USA RECALL CAMPAIGN

REF. NO. 48 FUEL DIVIDER BLOCK REPLACEMENT

F355 / 355F1

RECALL CAMPAIGN NO. 48 – Fuel divider block replacement.

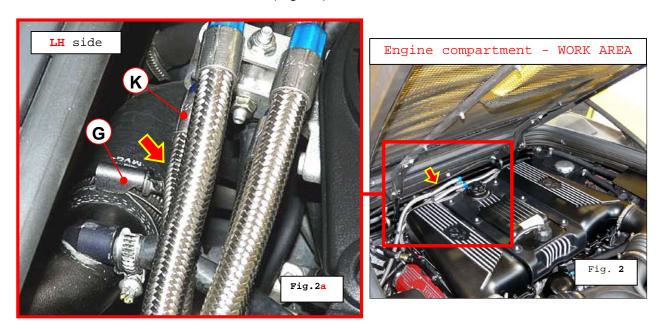
This **RECALL CAMPAIGN** involves the replacement of the fuel divider block Part. no. **165192** (Fig. **3** – page **3**) or Part. no. **178937** (Fig. **3**a – page **3**), with a new "**Fuel Divider Block Kit** – **F355**" **Part no. 70001495** - (Fig. **1**), **this kit** consists of:

A) - Complete fuel divider block	Part. no. 258700	Qty. 1
B) - Divider block fastening screws	Part. no. 14305534	Qty. 2
C) - Conical washer	Part. no. 11197774	Qty. 2
D) - Stud bolt M5	Part. no. 11000824	Qty. 1
E) – O-Ring seals	Part. no. 127816	Qty. 6
F) - Clip	Part. no. 140727	Qty. 11

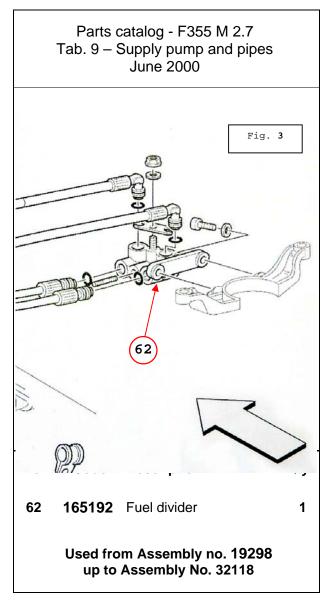
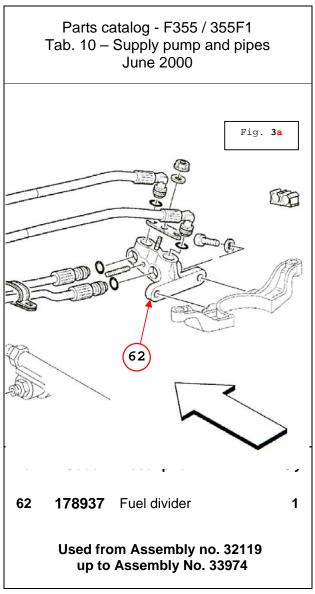
This service needs to be carried out in order to avoid a possible interference (**red arrow** – Fig. **2 / 2a**) which might occur between the fuel delivery **pipe** (**K**) - **Part. no. 171344** from the divider block to the LH injector rail, and **screw clamp** (**G**) - **Part. no. 13000690** fastening the thermostat connection water sleeve (Fig. **2a**).

Interference of the clamp with the fuel line could possibly:

- (i) cause pipe (K) (Fig. 2a page 2) to rub through, and consequently cause fuel leakage, and possibly a fire.
- (ii) cause the engine to malfunction.

The improper installation or the incorrect orientation of **screw clamp** (G) – (Fig. 2a – page 2), could possibly cause, over time, damage of the fuel delivery pipe.

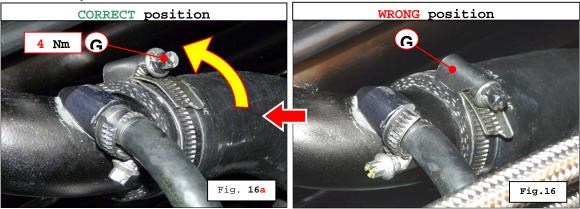
- **2.15** Check the position of **screw clamp** (**G**) **Part. no. 12177090**, which fastens the thermostat connection water sleeve:
 - in case this is in the WRONG position as shown in Fig. 16, loosen it and turn it upwards (yellow arrow), bringing it to the CORRECT position as shown in Fig. 16a. (This was also required in Recall Campaign no. 158). After ensuring the screw clamp is in the correct position as shown in Fig.11a, tighten the screw clamp to a torque of 4 Nm.

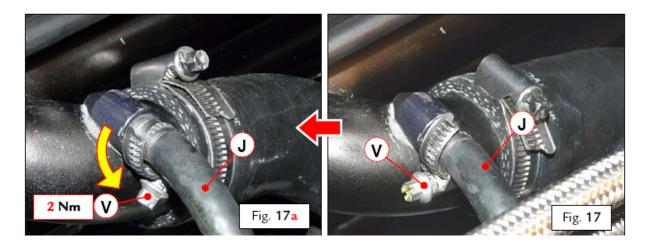
2.16 Loosen screw clamp (V) Part. no. 13000190 (Fig. 17) which fastens the small water pipe and turn it downward (yellow arrow) to the position as shown in Fig. 17a. Tighten to a torque of 2 Nm.

NOTE: Carefully check the condition of pipe (J) in the area of the screw clamp (V) - NO cracks must be present - If necessary, replace the pipe Part No 161609.
